RE: **#06ITB49977K-RS, Southwest Arts Center**

**Addendum No. 5**

**SW Arts Phase II Performance Theatre**  
**ITB No. 06ITB 49977K-RS**  
**Addendum 5**  
**7/07/2006**

SHEET NO.  
**SK53**

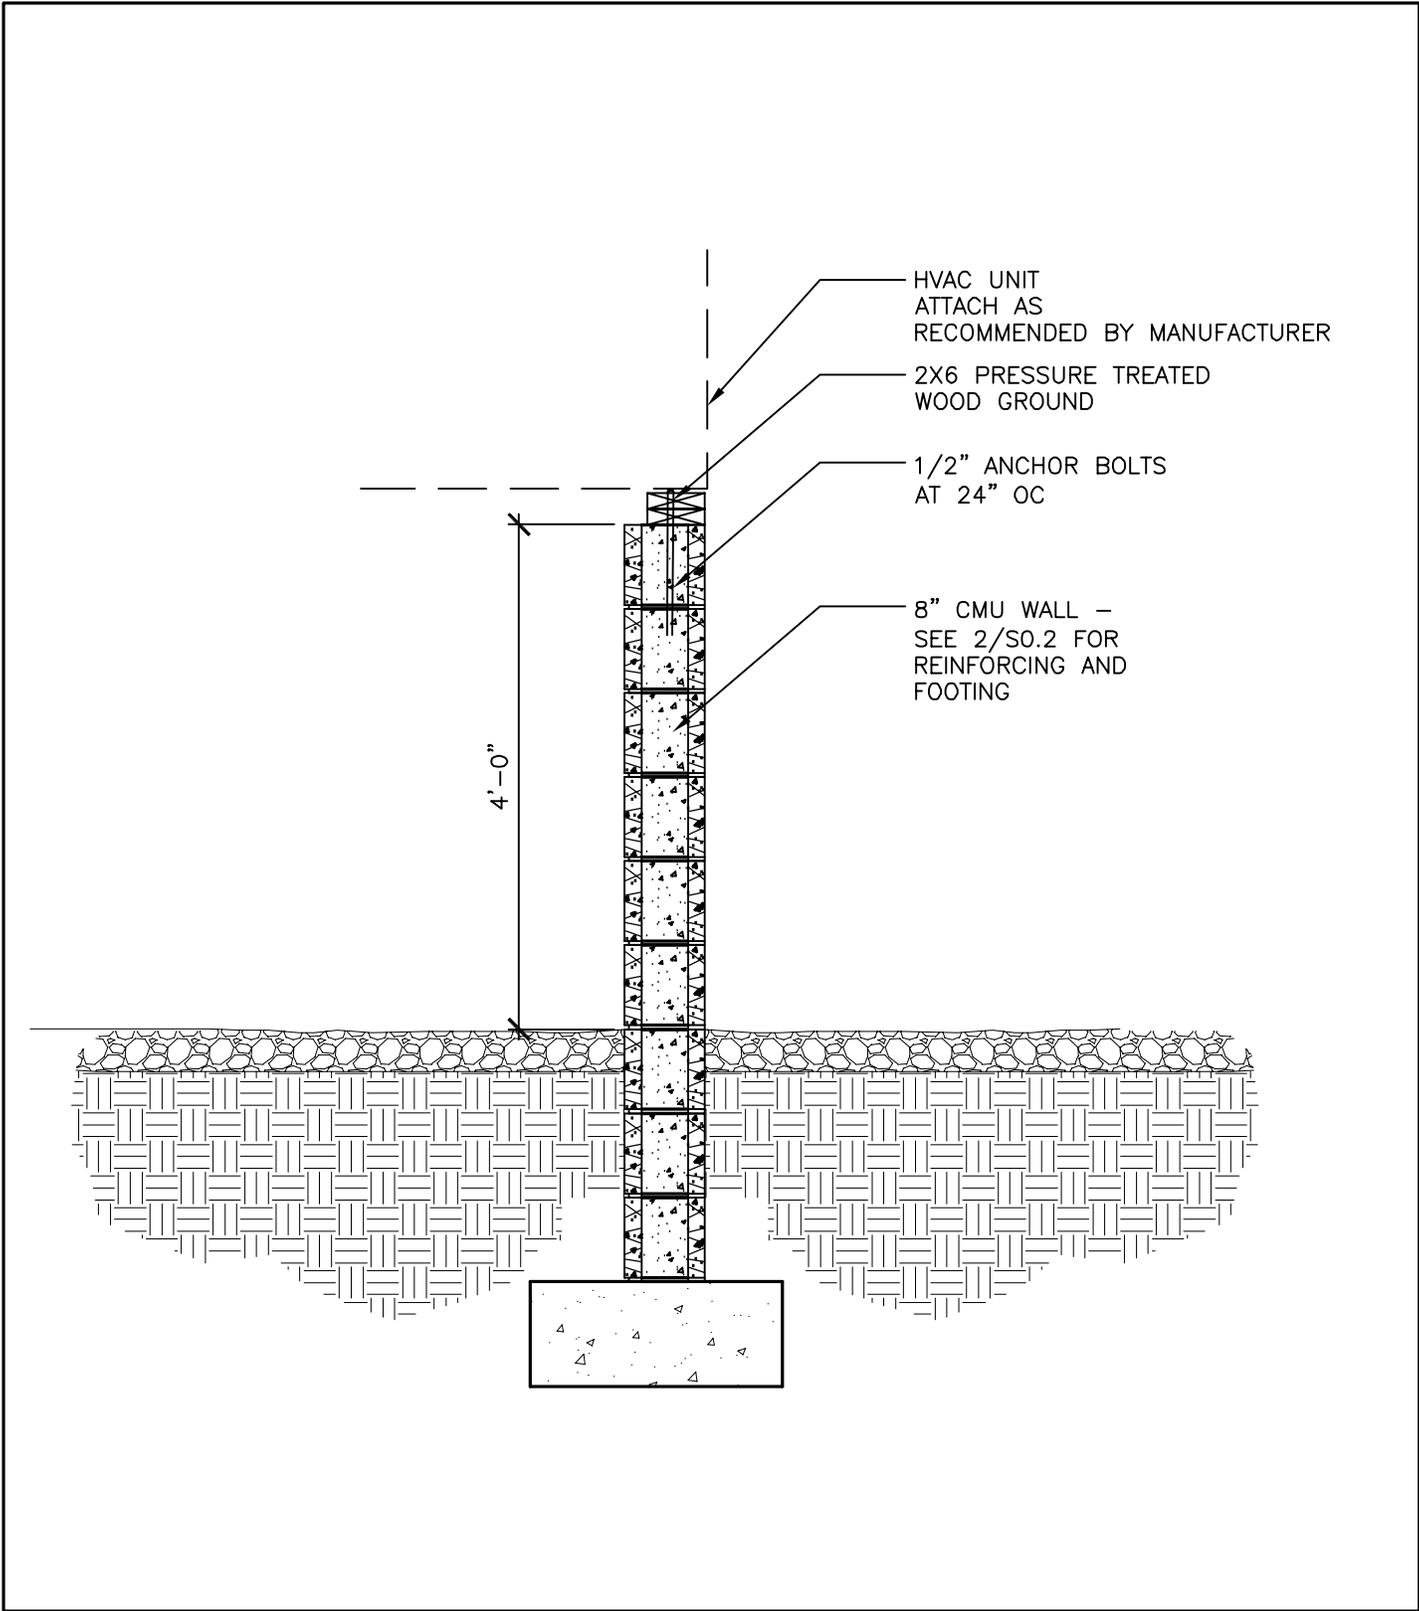
- P Lithonia KBD8 100 S R5 TB LPI
  - T ConTech LT-4/8-P
  - T1 ConTech CTL2240-P
  - Y ConTech RTH-4/RTH-8 RAH-10
  - Y ConTech CTL8235S20MH6-P
3. **Q:** Clarify retaining wall at sidewalk south of south service entrance

- A:** Issue SK 53. This retaining wall is to be modular block construction similar to all the other retaining walls and with an adjacent handrail as detailed on sheet C10.

(2) 12' SWING GATES.  
MATCH EXISTING GATES AND  
POLES AT MAIN ENTRANCE  
**MODULAR BLOCK  
RETAINING WALL**  
SEE C2 & C2.1 FOR T.O.W.  
ELEVATIONS.
